PIC18C658/858 Rev. B2 Silicon/Data Sheet Errata

The PIC18C658/858 parts you have received conform functionally to the Device Data Sheet (DS30475A), except for the anomalies described below.

FIGURE 1: PIC18CXX8 VOLTAGE-FREQUENCY GRAPH (INDUSTRIAL, EXTENDED)

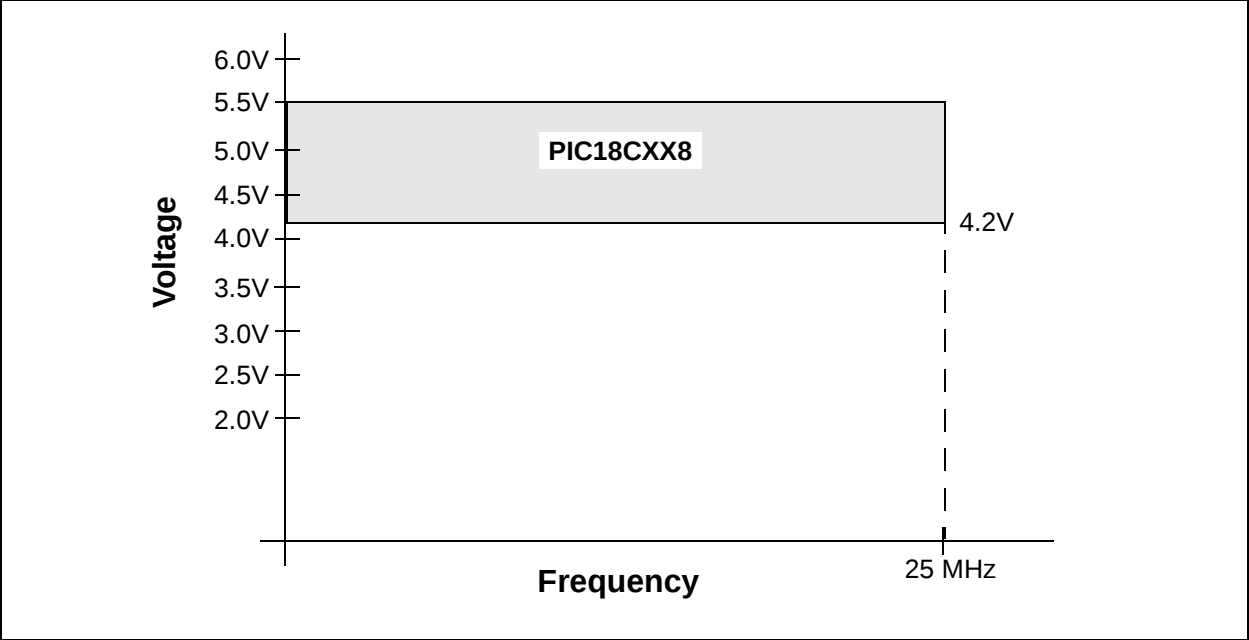
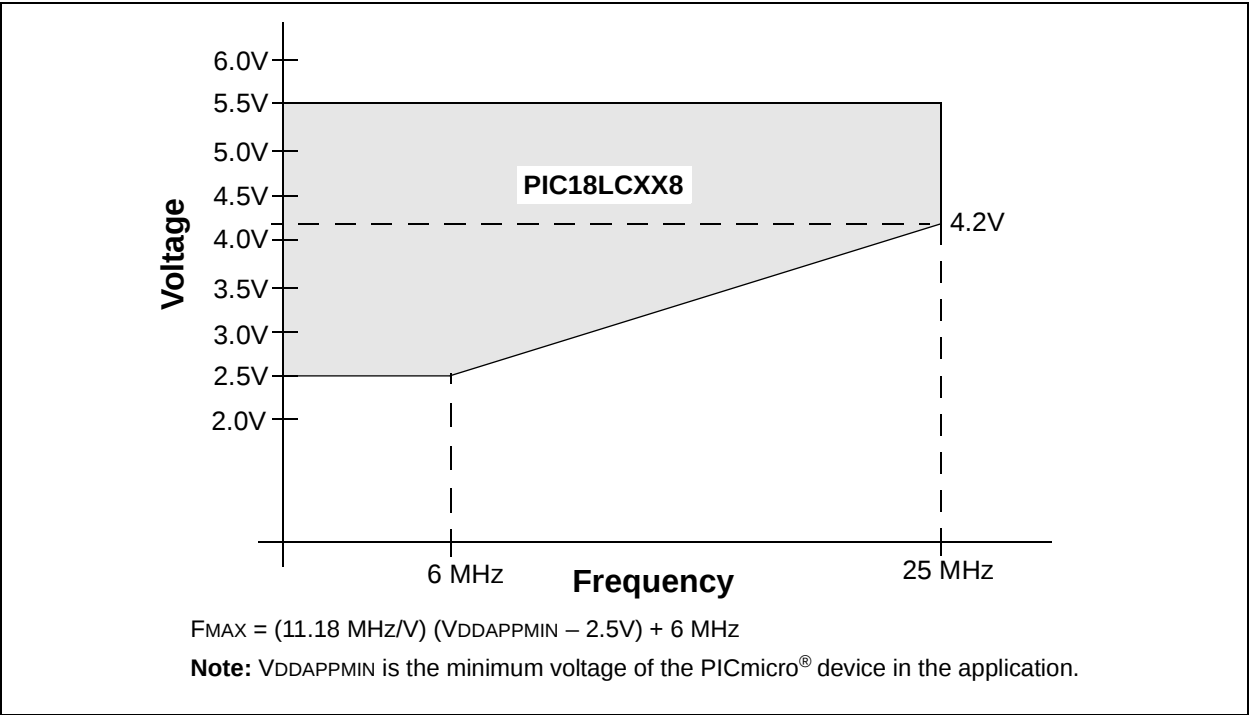
10. Module: Core (Voltage vs. Frequency)

The device may not operate properly at frequencies exceeding 25 MHz. The graphs in Figures 1 and 2 (page 4) show the expected voltage vs. frequency operating range for standard voltage range and extended voltage range devices, respectively.

The title of Figure 25-1 is amended to read:

“PIC18CXX8 Voltage-Frequency Graph (Industrial, Extended)”

Work around

None. This issue is expected to be resolved in a future silicon revision. Please contact a Microchip sales office for additional information on availability.

FIGURE 1: INTERRUPT LOGIC (EXCERPT)

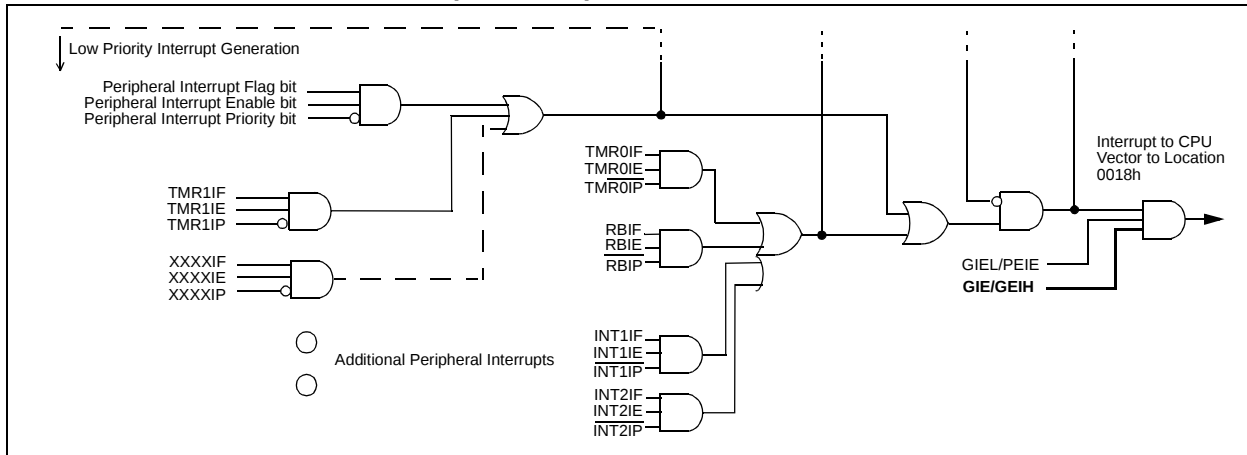
Also, the interrupt logic funnel shown in Figure 7-1 of the Device Data Sheet is amended with the addition of a GIE/GIEH control line, as shown in Figure 1 (new material in **bold line**).

The operation of the GIE/GIEH bit (INTCON<7>) is clarified as follows: when the bit is cleared, all interrupts are disabled. This is regardless of the state of the IPEN bit (RCON<7>), the priority of the interrupt, or whether or not the interrupt is unmasked. This varies from the original description, in which clearing the bit when IPEN = 1 would only disable high priority interrupts.
